Emon Fashion Ltd.

7th June 2018

Observations

Provided beam Layout for above roof level

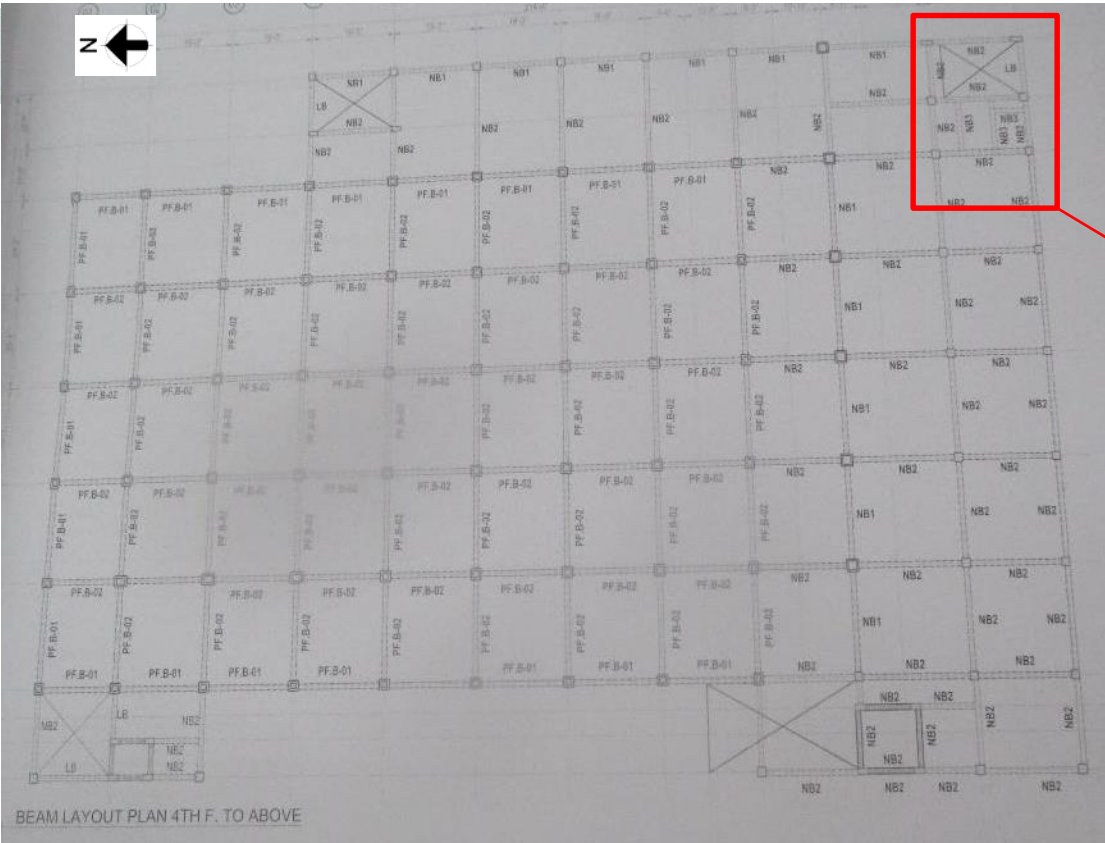
Red marked beams (350mm d/sX300mmW) were not shown in provided beam layout for above roof level. Factory engineer is required to update the beam layout

Undocumented beam

Undocumented beam

Provided beam Layout for 4th to above roof level

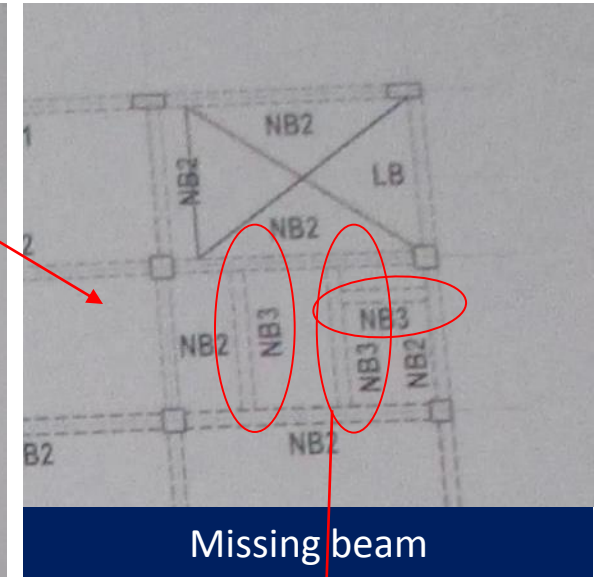
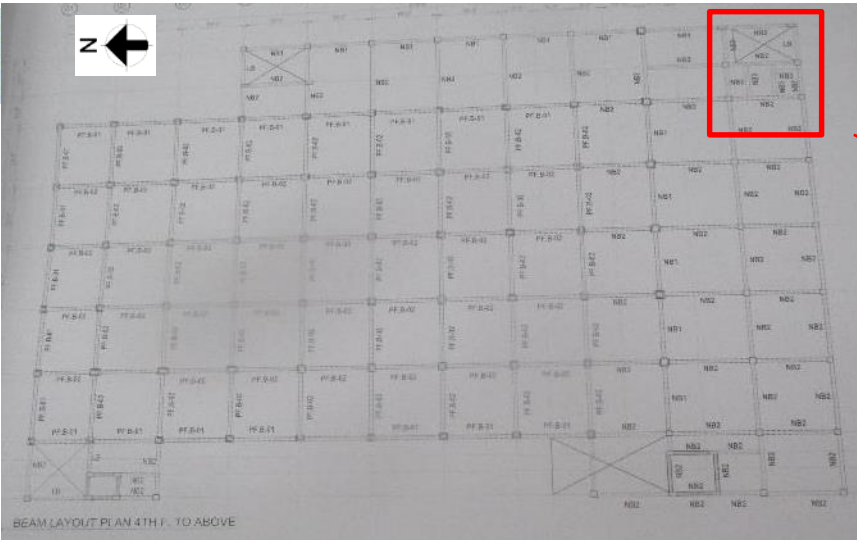
Marked beams were shown in beam layout for 1st, 2nd, 4th, 5th floor and top slab but those beam were observed only at 2nd and 3rd floor. Factory engineer is required to update the beam layout.

Missing beam

Missing beam

Provided beam Layout for 3rd floor

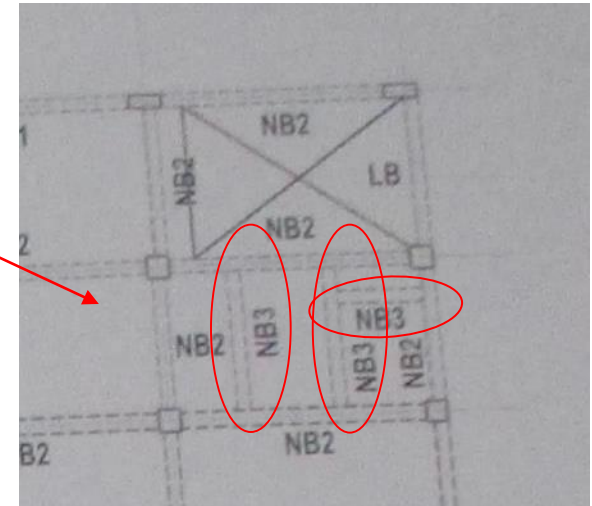
Missing beam

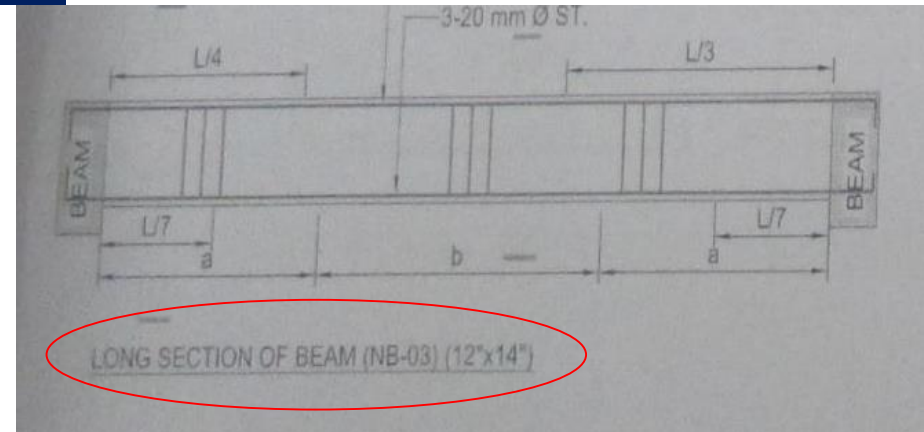
Width of NB was measured as 250 mm

Width of NB-3 was shown as 300 mm in provided drawing but in as-built condition width was observed as 250 mm. Factory engineer is required to update the beam layout.
